**NSLPP MEETING HELD ON 05/04/2023****Attachments:**

**ADDRESS/WARD:** Unit 2, 5 East Avenue, Cammeray**APPLICATION No:** DA 269/2022**PROPOSAL:** A roof addition to an existing dwelling within a two storey attached dual occupancy to construct an additional bedroom with an ensuite.**PLANS REF:**

**OWNER:** James Dimic and Jennifer Dimic**APPLICANT:** Dieppe Design Pty Ltd**AUTHOR:** Michael Stephens, Senior Assessment Officer**DATE OF REPORT:** 27 March 2023**DATE LODGED:** 8 September 2022**AMENDED:** 23 January 2023**SUBMISSIONS:** 5 Objections**RECOMMENDATION:** Approval

**Figure 15. Location of proposed height variations**

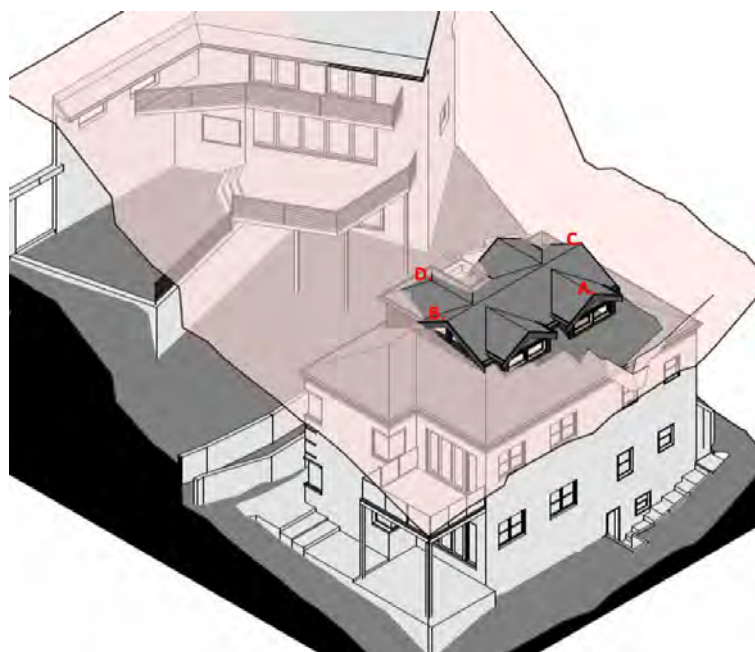
The extent of the proposed variations is identified in the table below referencing the diagram in **figure 15** below. The proposed additions have a maximum building height of 9.8m being a variation of 1.3m or 15.3%. The lateral extent of the variation relates to the whole of the roofs central gabled form and dormers with the surrounding re-pitched roof form complying with the development standard with the exception of a small area above the previously excavated lower ground floor communal storage area on the northern side of the building. The proposed ridgeline represents the maximum height of the building and results in a variation of 1.0m or 11%

Non-compliant Building Element	Control	Height	Variation
A.	Northwestern Dormer	8.5m	9.8m	1.3m (15.3%)
B.	Central Ridgeline (Eastern End)		9.5m	1.0m (11.7%)
C.	Central Ridgeline (Western End)		9.5m	1.0m (11.7%)
D.	Southeastern Dormer (Staircase)		9.2m	0.7m (8.2%)

Figure 16. Section A

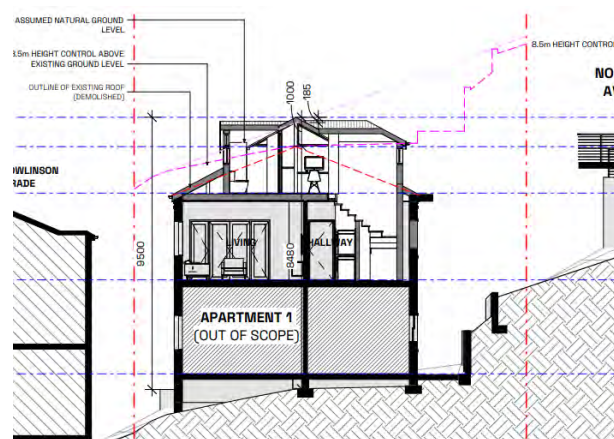
As an observation the extent of the excavation to construct the original building is likely greater than any fill given the height of the retaining walls to the south of the site in comparison to the height of the subfloor to the north of the building, meaning that the overall height of the building is somewhat penalized by the excavation. The development would be significantly more compliant with the development standard if the land level was transposed from boundary to boundary as demonstrated in **Figure 16** above.

**A1.11 - 4**  
 PROJECT:  
**5 EAST AVE, CAMMERAY**  
 CLIENT:  
**JAMES & JEN DIMIC**  
 DRAWING TITLE:  
**LEVEL 3 - UNIT 2 ATTIC**  
 ISSUE DATE: 2023.01.16 SCALE @A1: 1:50 PROJECT NO.: 2021

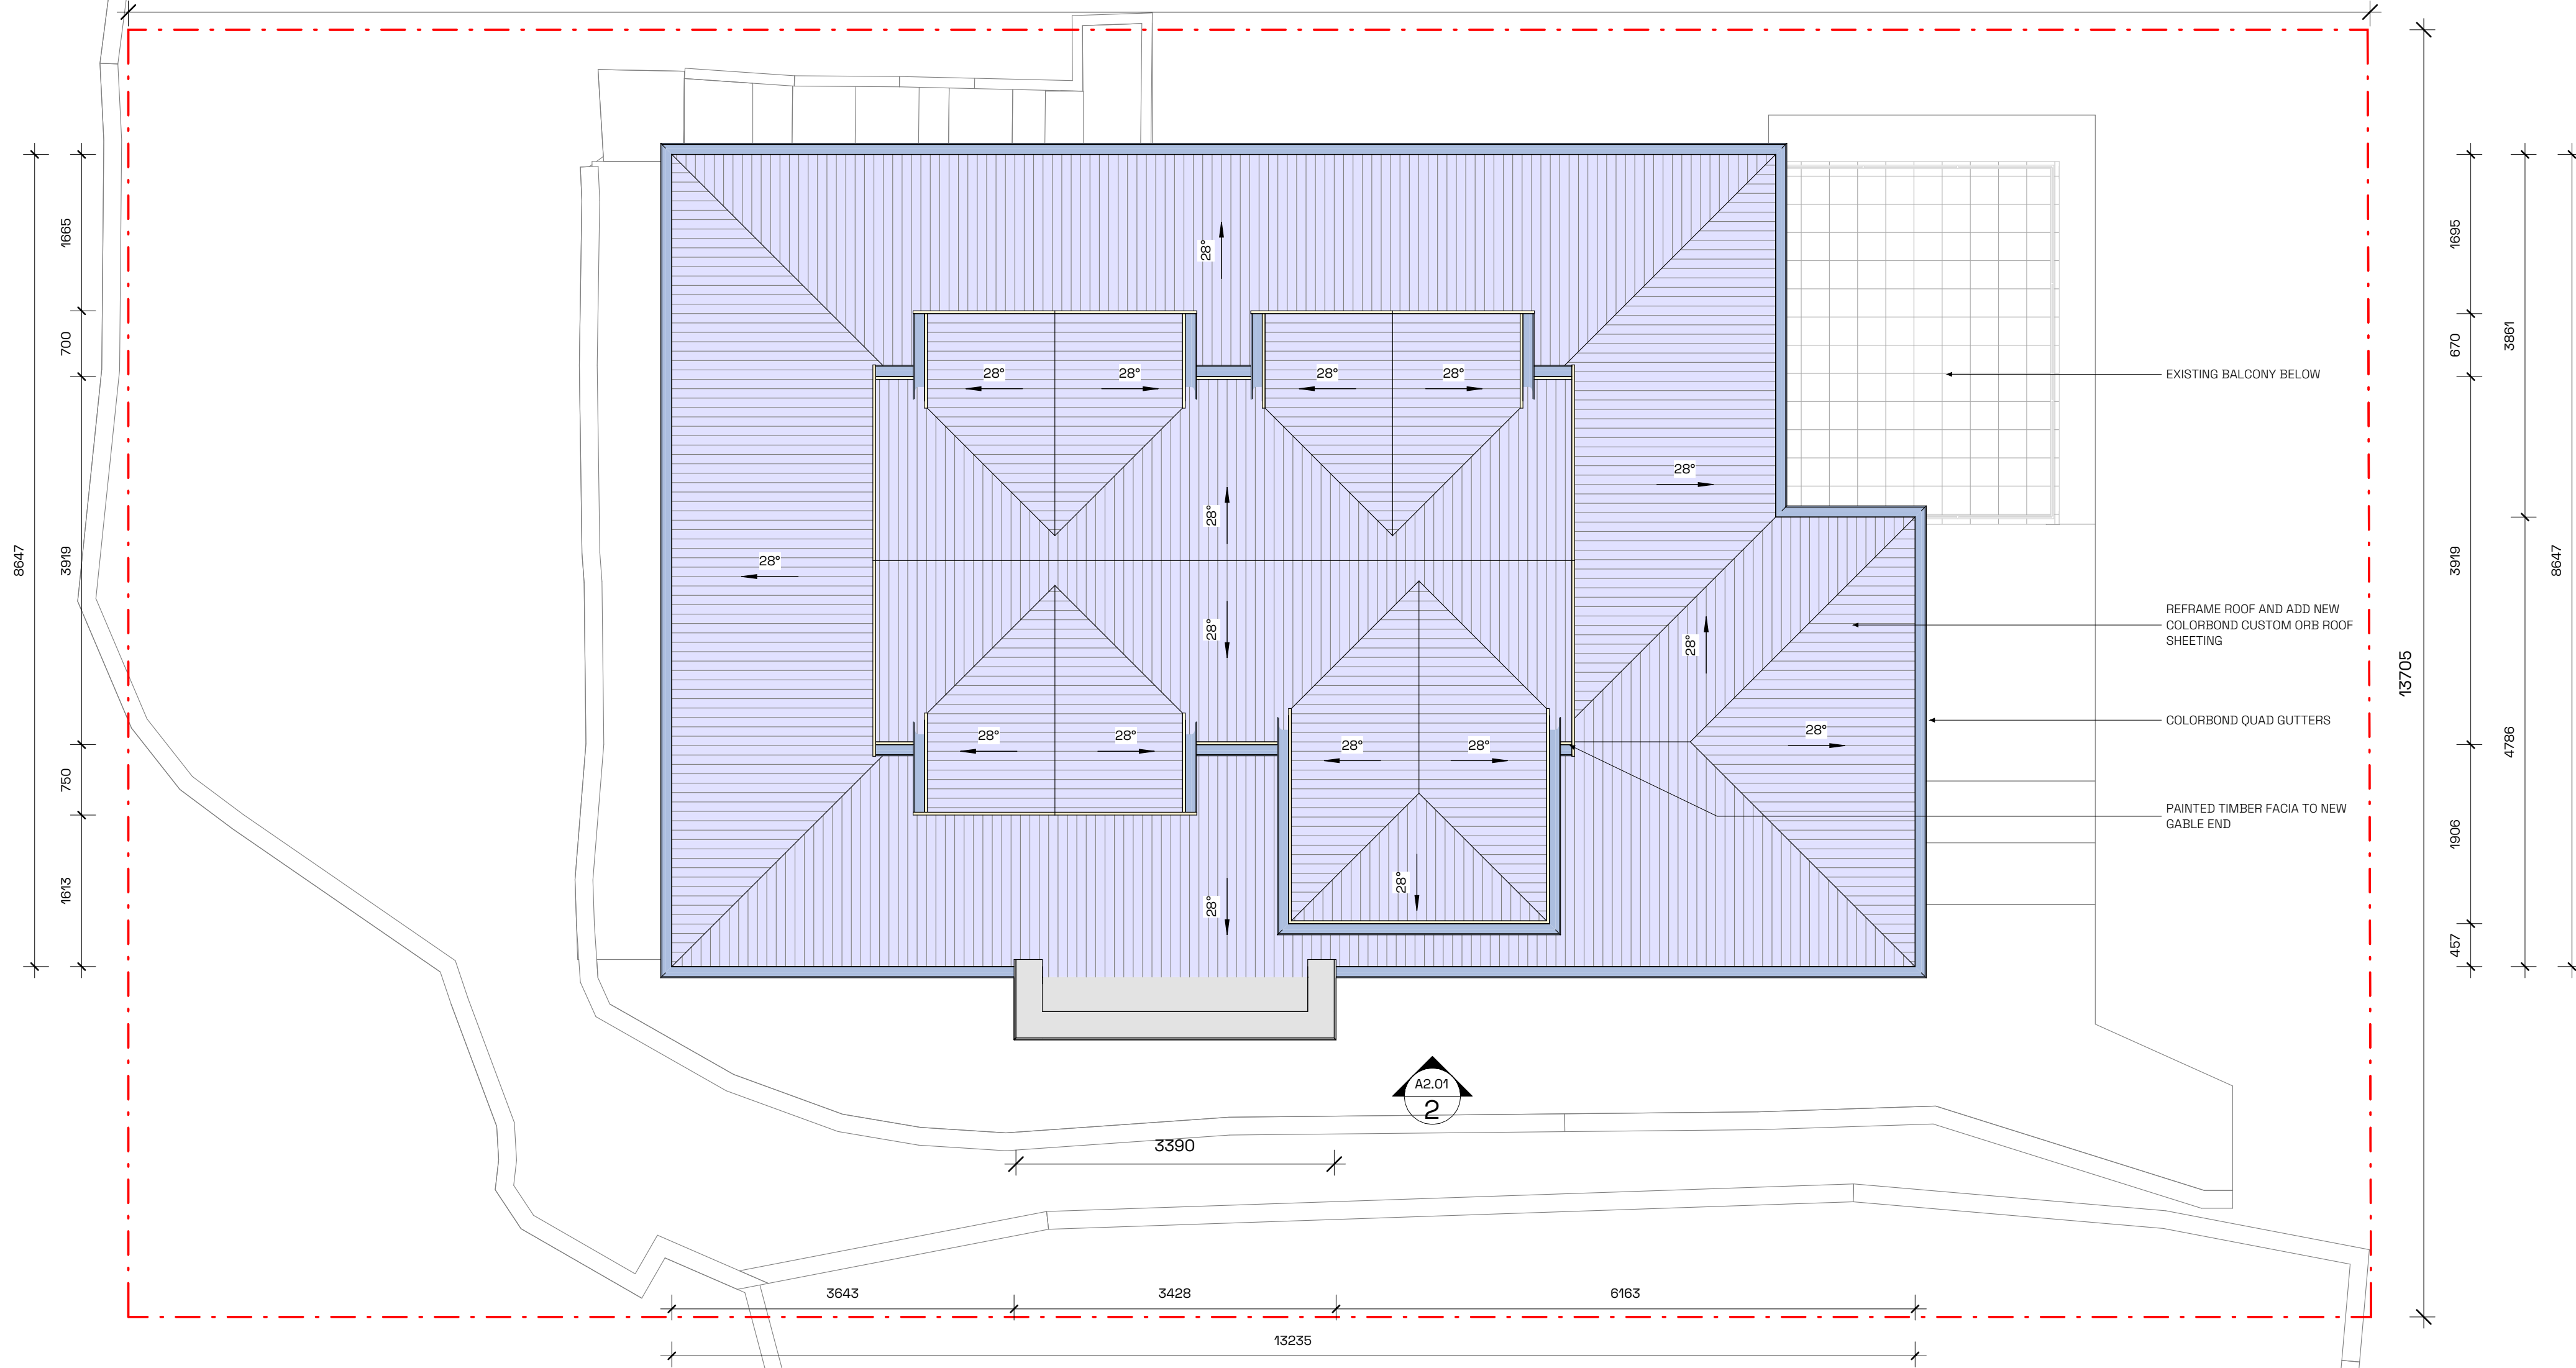
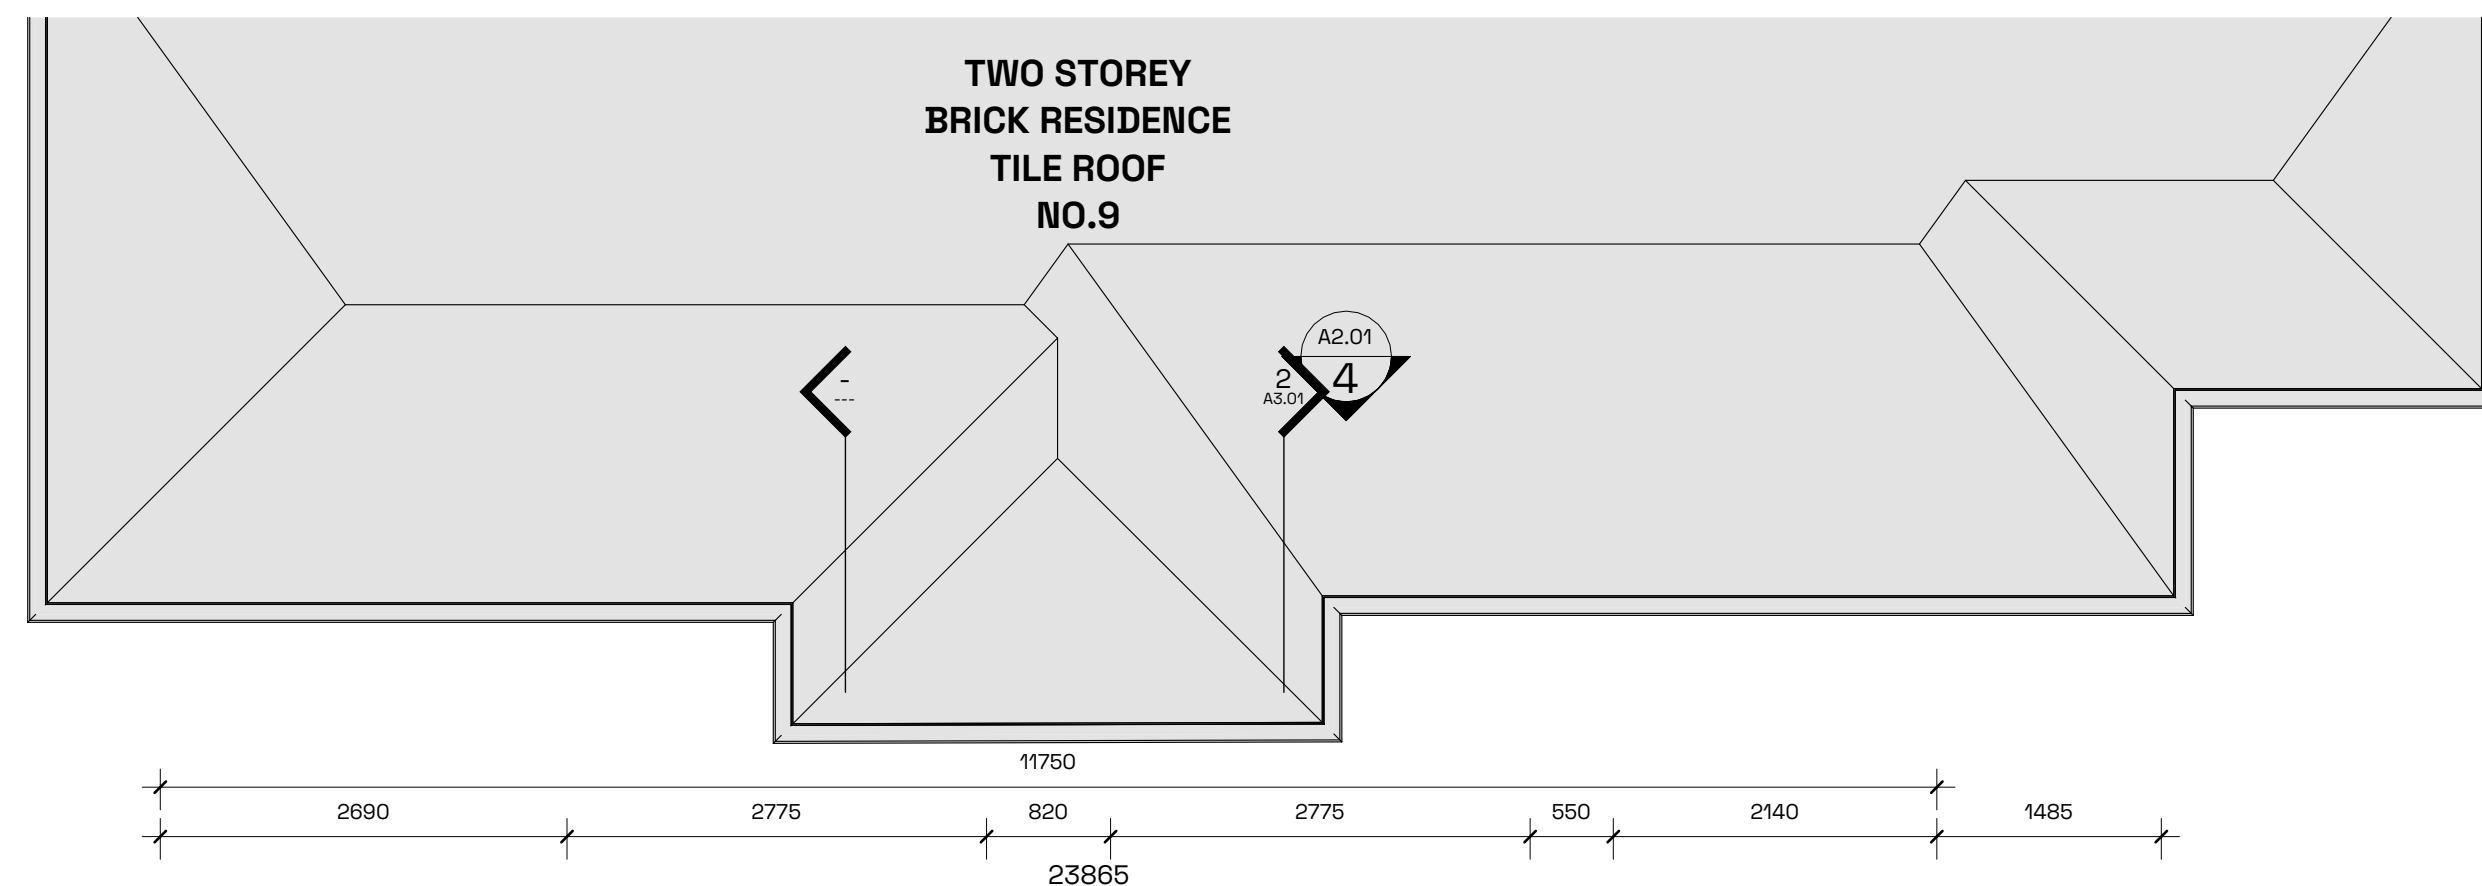
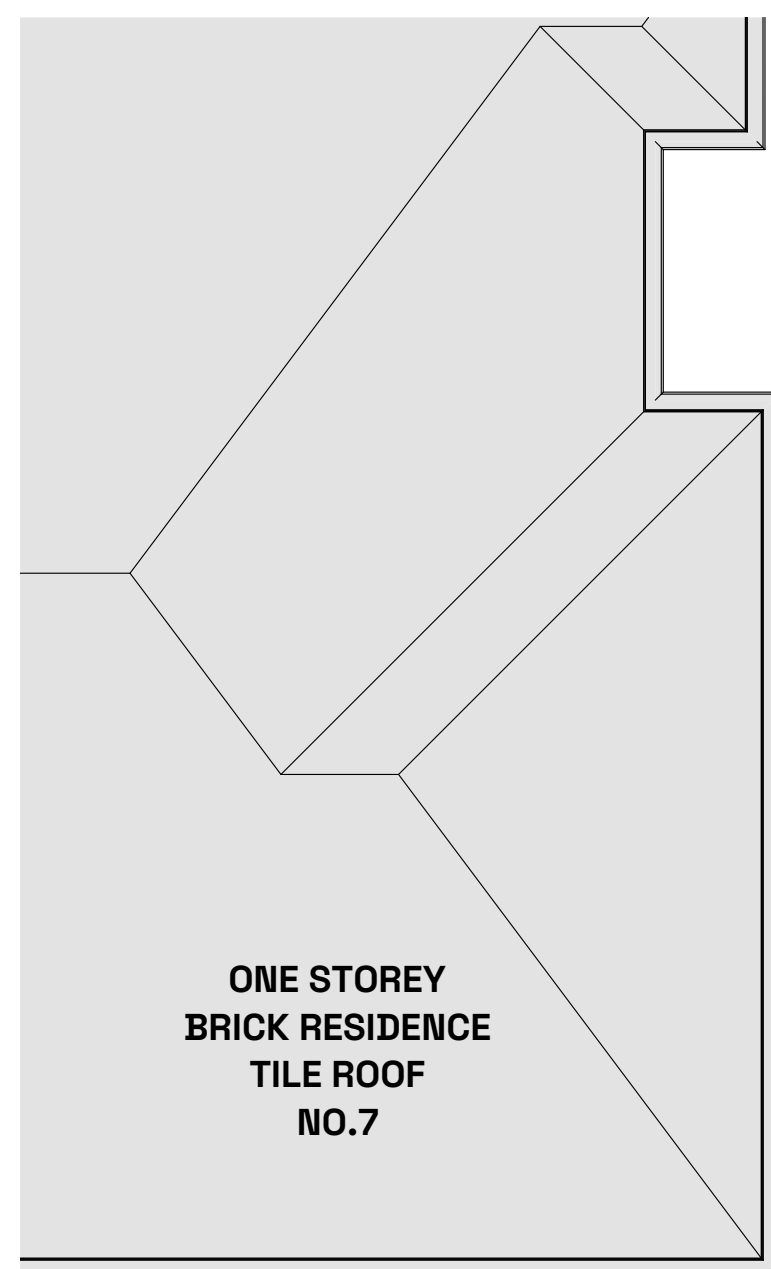
- (a) Windows W.03 and W.04 on the southern elevation of the second floor level (drawing reference A1.11-4) should be fitted with obscure or frosted glazing and the opening aperture is to be limited to 100mm to still allow ventilation whilst retaining privacy between the subject dwelling and the adjoining property to the south.
